IGLU MASCOT II
13A CHURCH AVENUE,
MASCOT

Schedule of changes:

IGLU MASCOT II
13A CHURCH AVE

A01
Site and Analysis Plan

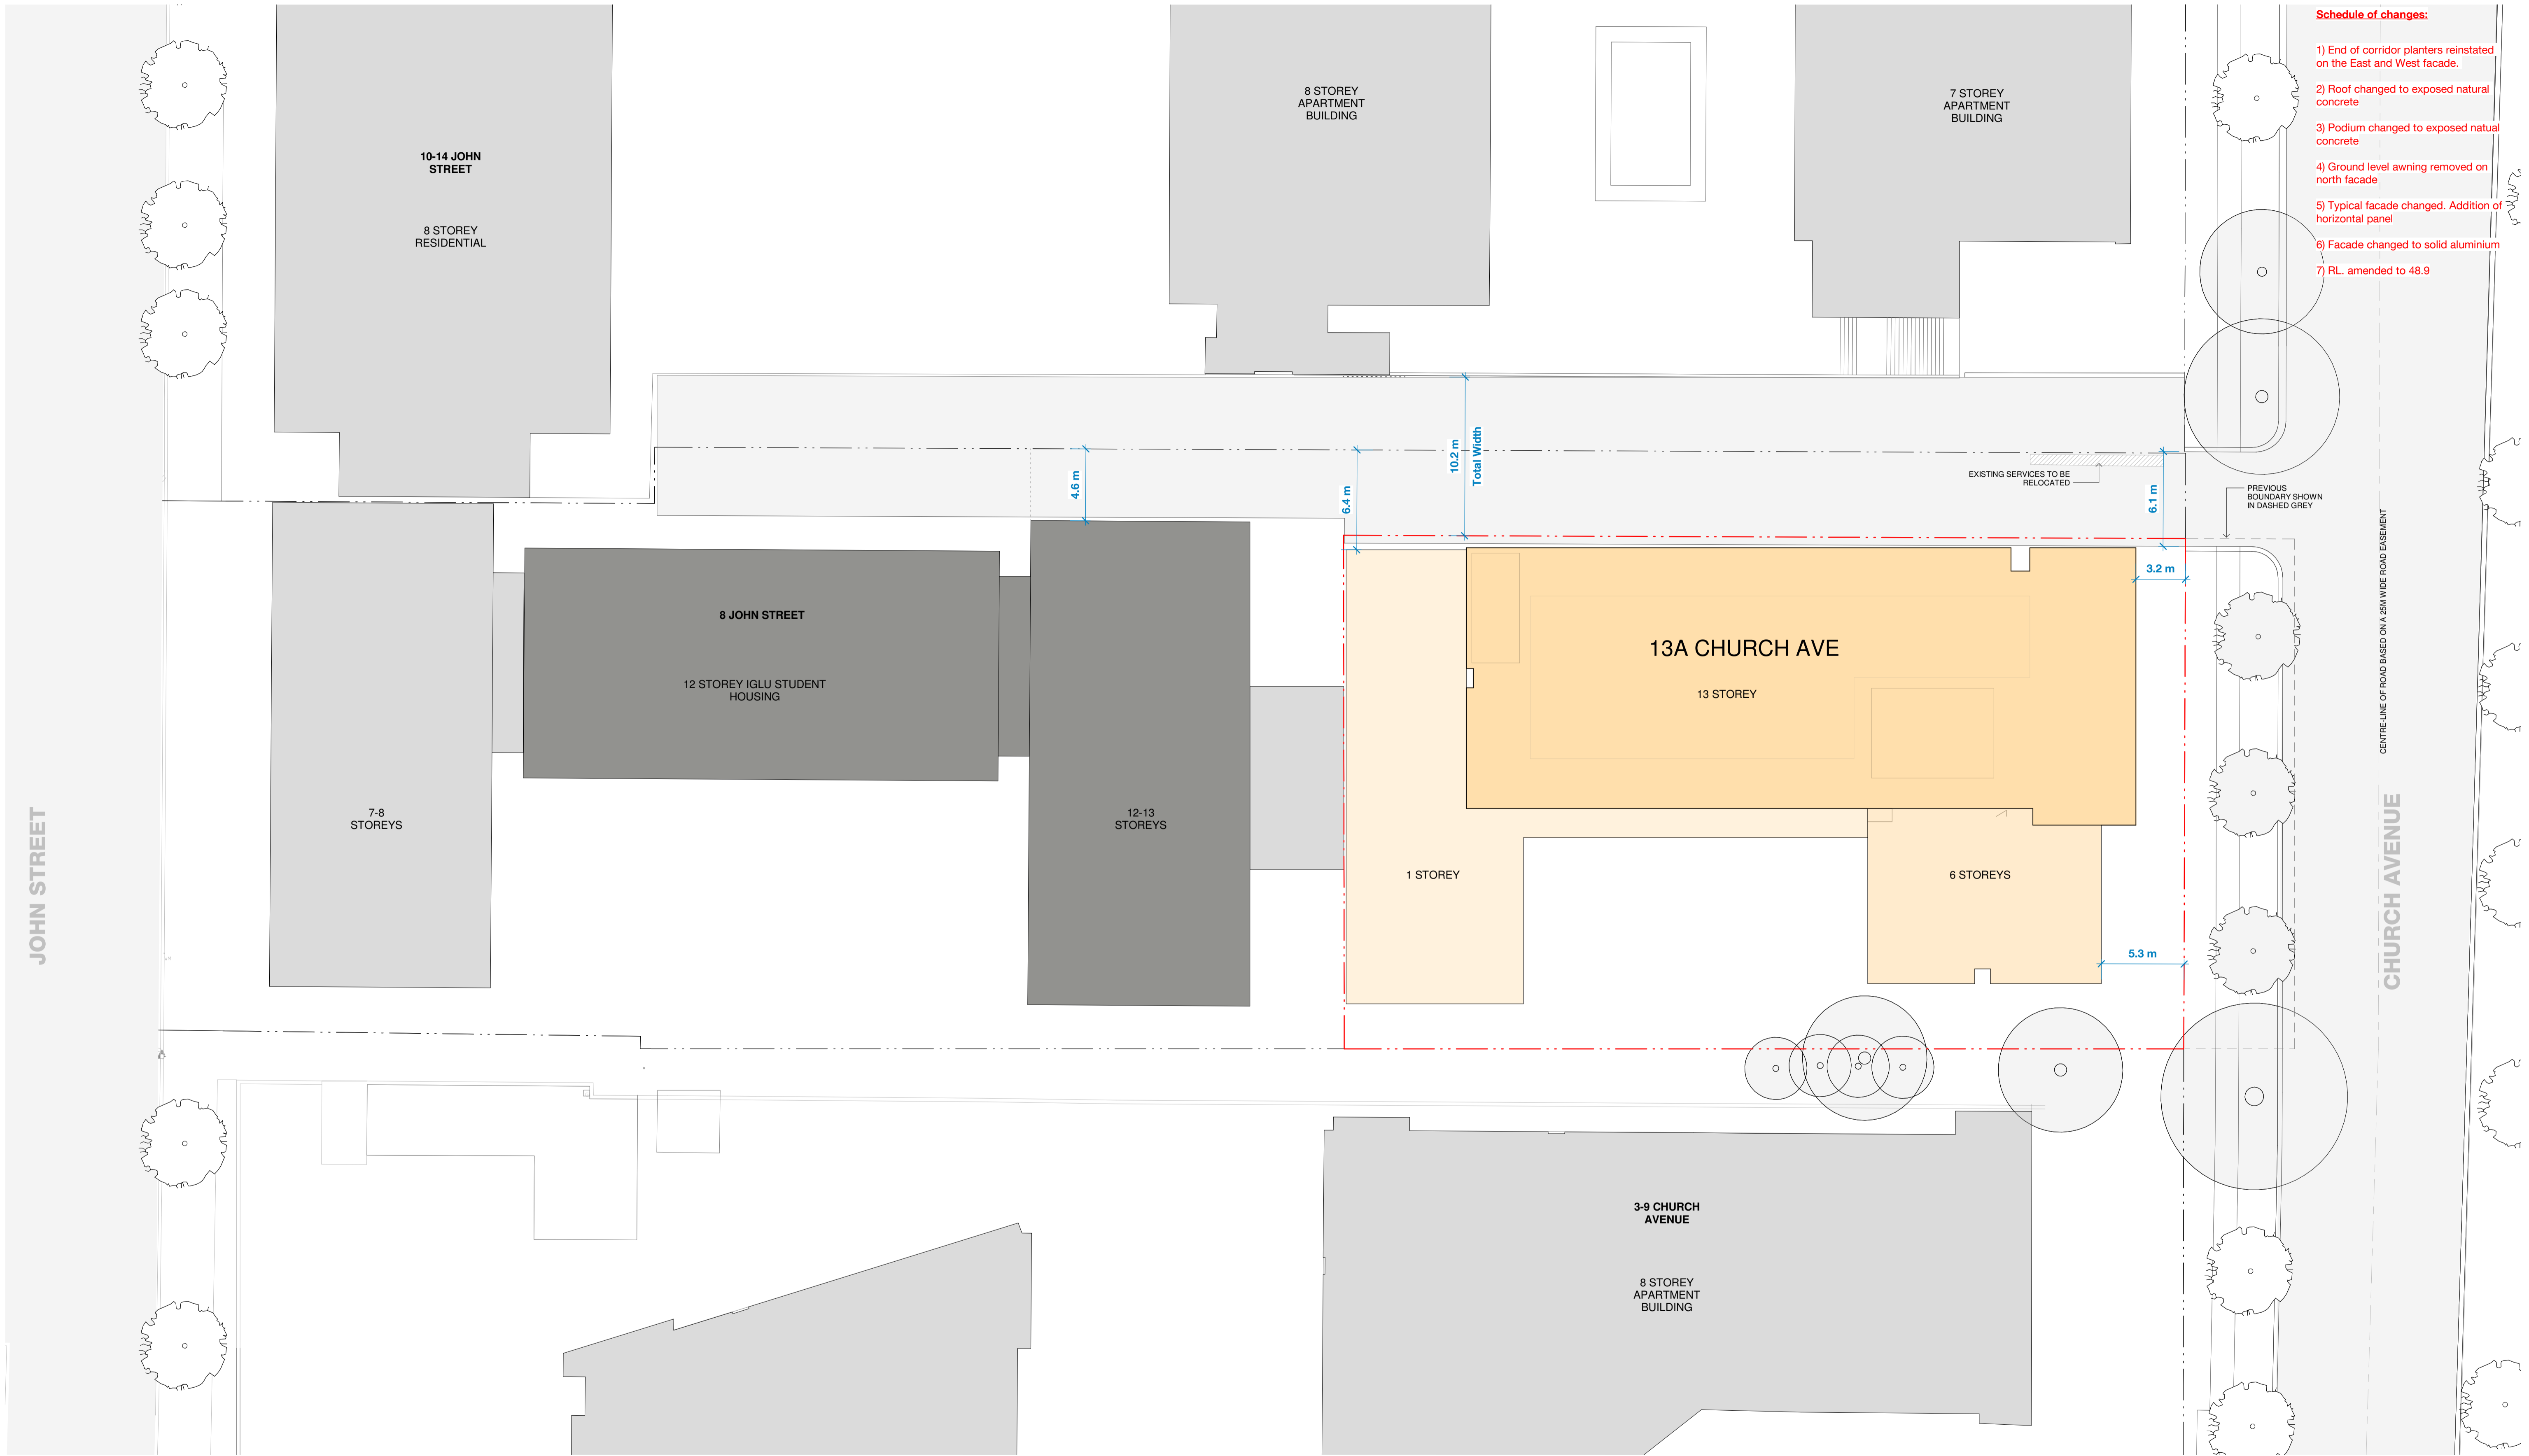
- 1) End of corridor planters reinstated on the East and West facade.
- 2) Roof changed to exposed natural concrete
- 3) Podium changed to exposed natural concrete
- 4) Ground level awning removed on north facade
- 5) Typical facade changed. Addition of horizontal panel
- 6) Facade changed to solid aluminium
- 7) RL amended to 48.9

General Arrangement Plan
Level 01

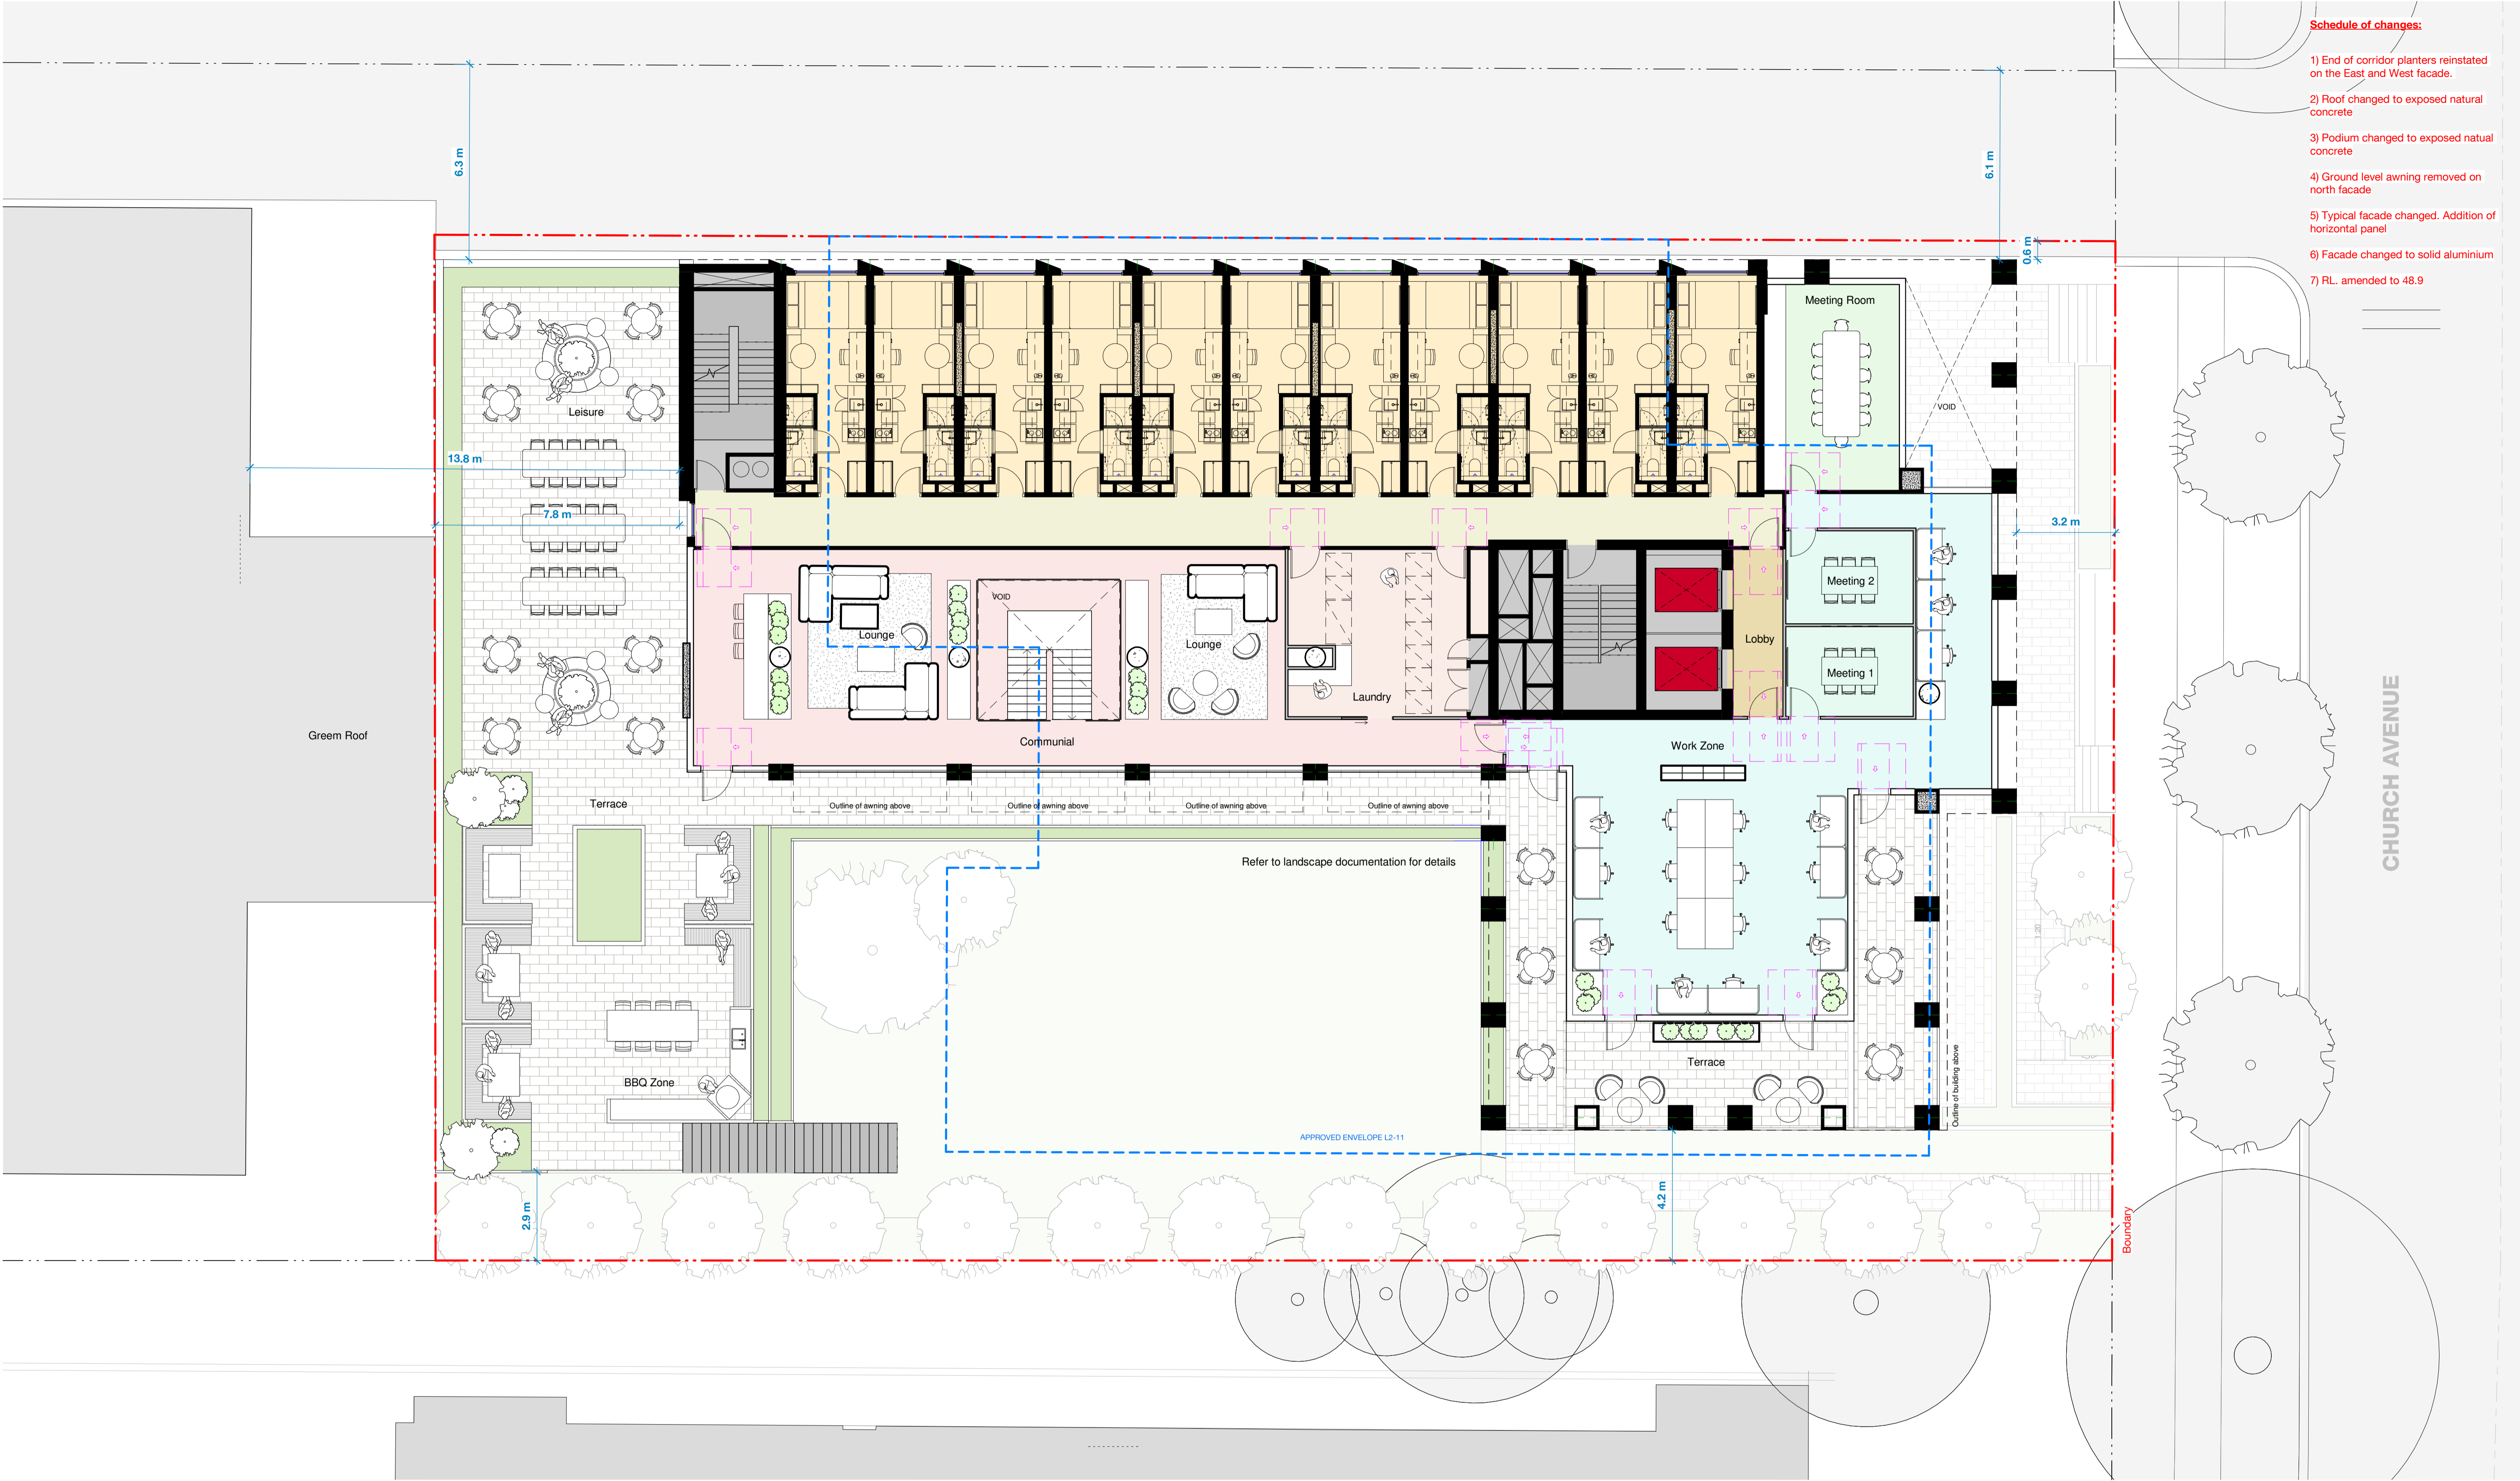
- Schedule of changes:**
- 1) End of corridor planters reinstated on the East and West facade.
 - 2) Roof changed to exposed natural concrete
 - 3) Podium changed to exposed natural concrete
 - 4) Ground level awning removed on north facade
 - 5) Typical facade changed. Addition of horizontal panel
 - 6) Facade changed to solid aluminium
 - 7) RL. amended to 48.9

**General Arrangement Plan
Typical Upper Levels - L07 - L11**

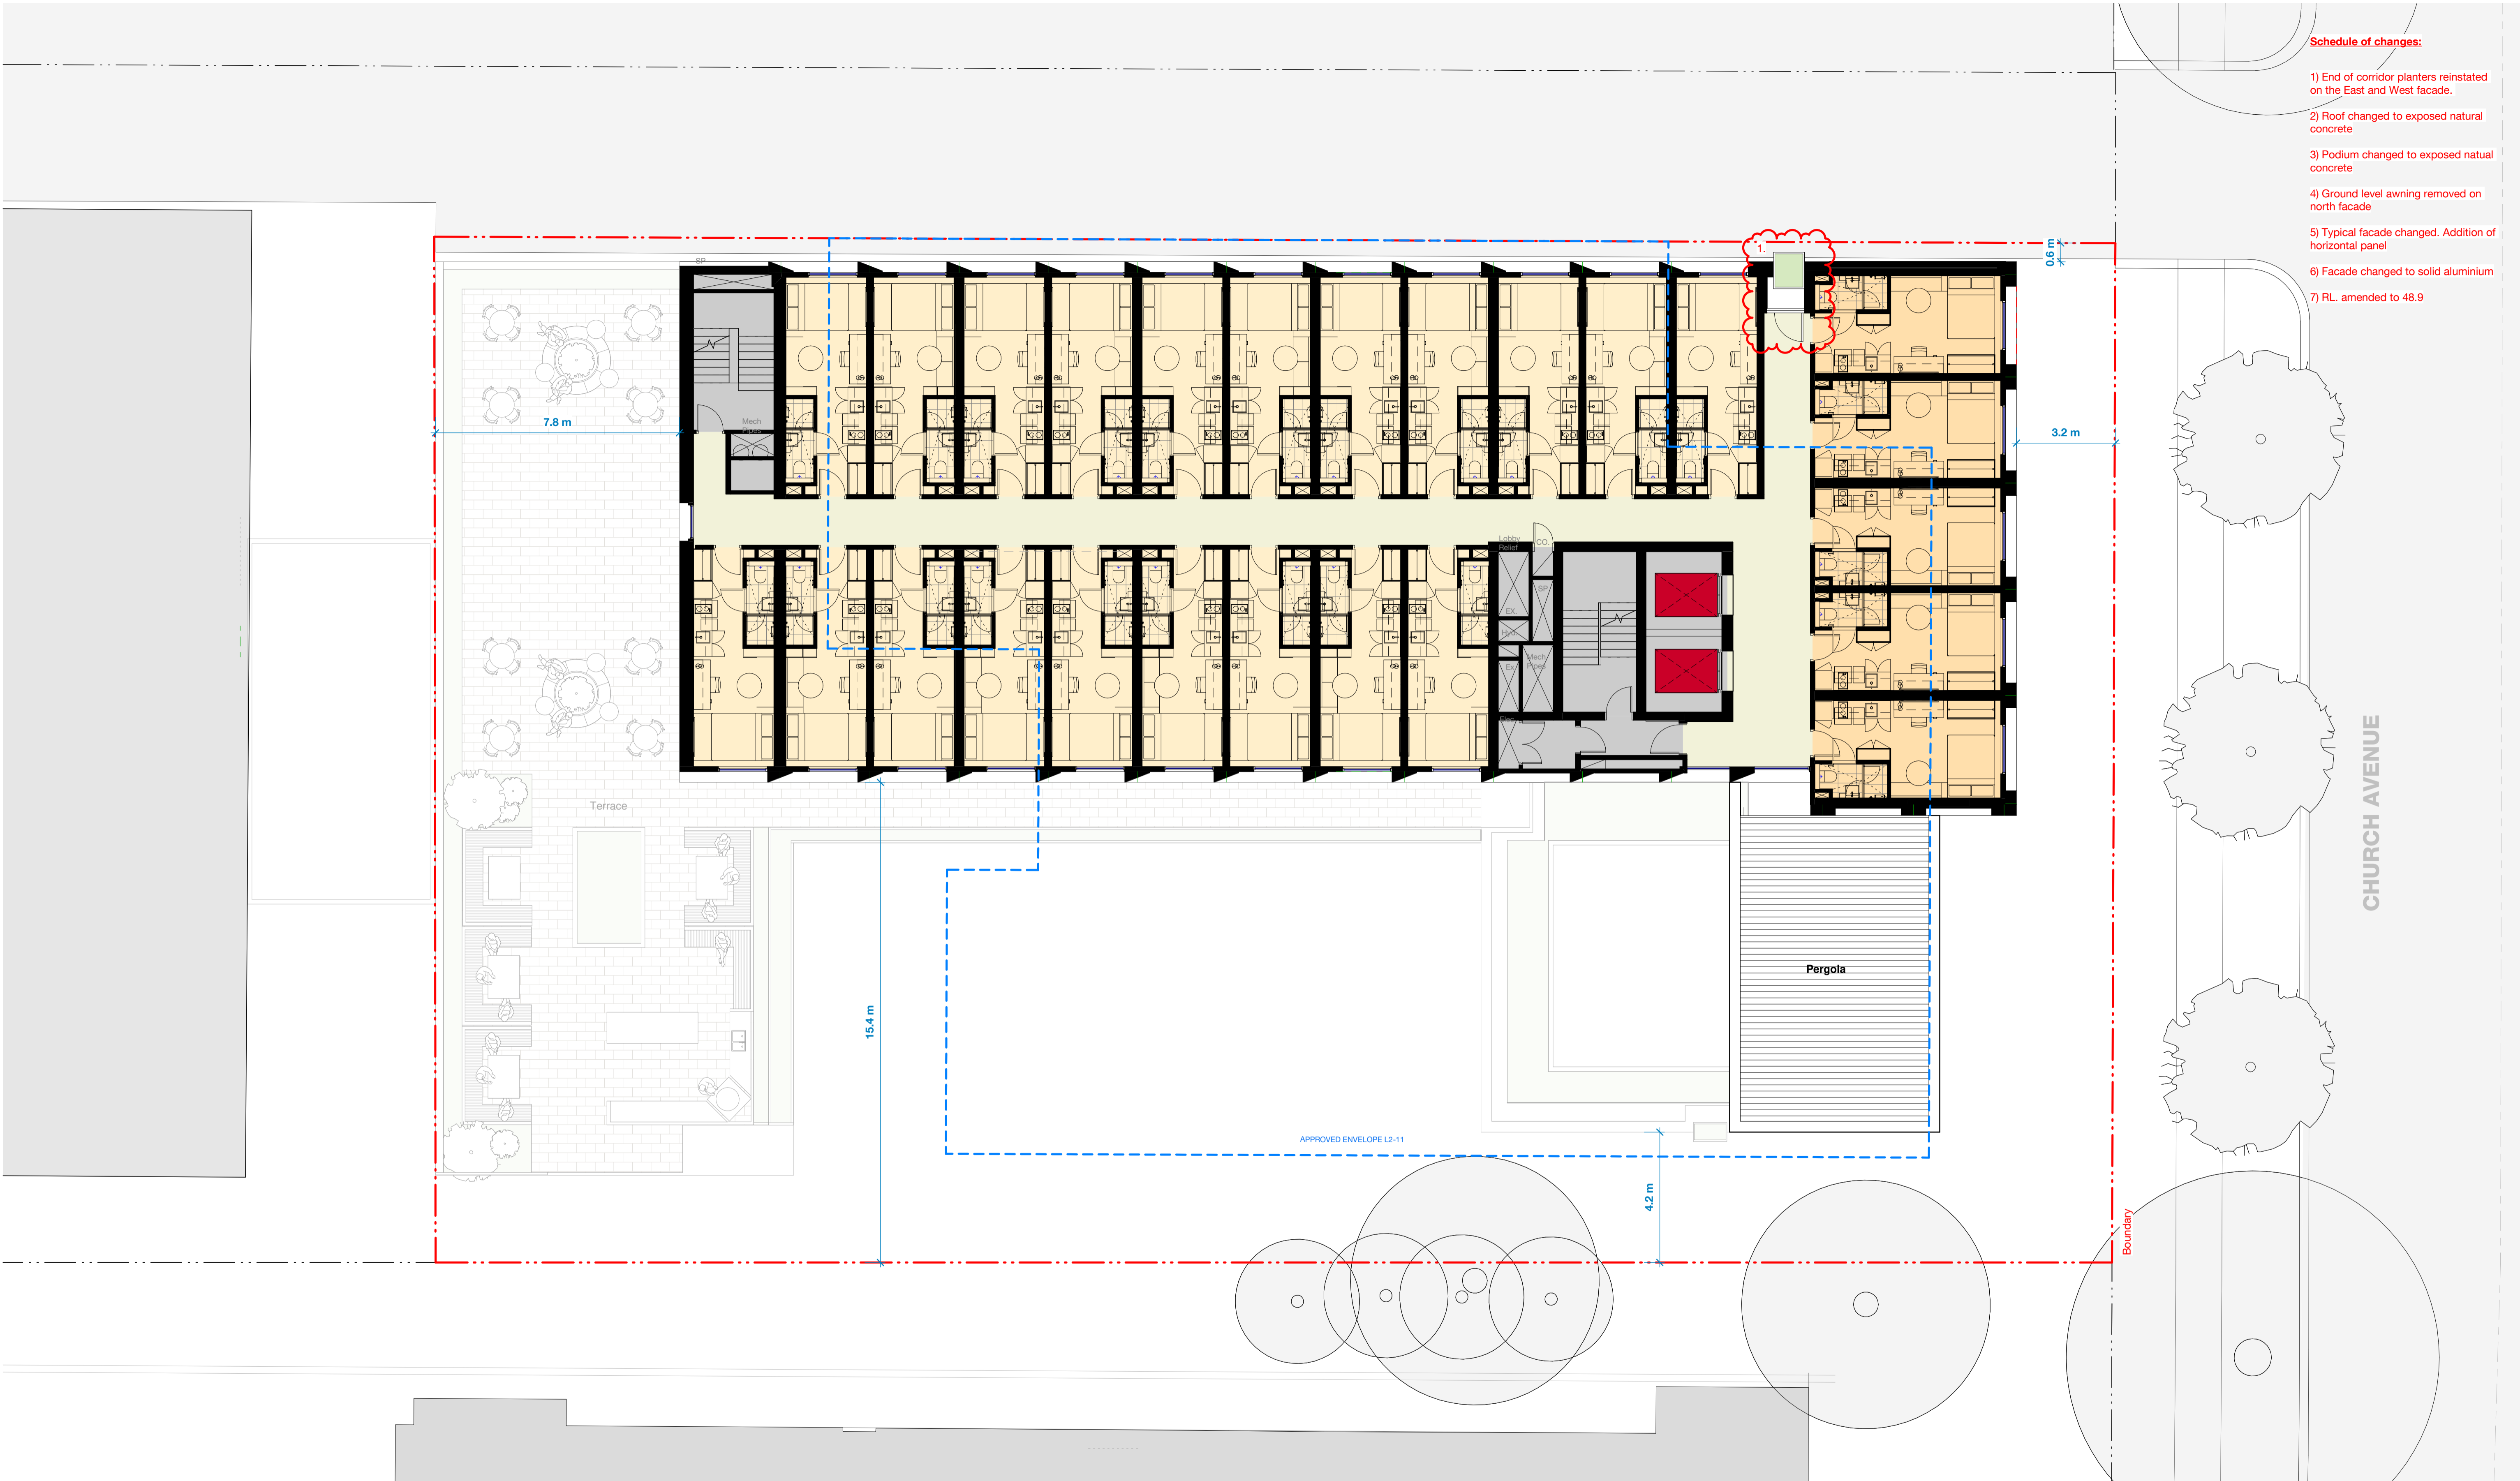
- Schedule of changes:**
- 1) End of corridor planters reinstated on the East and West facade.
 - 2) Roof changed to exposed natural concrete
 - 3) Podium changed to exposed natural concrete
 - 4) Ground level awning removed on north facade
 - 5) Typical facade changed. Addition of horizontal panel
 - 6) Facade changed to solid aluminium
 - 7) RL. amended to 48.9
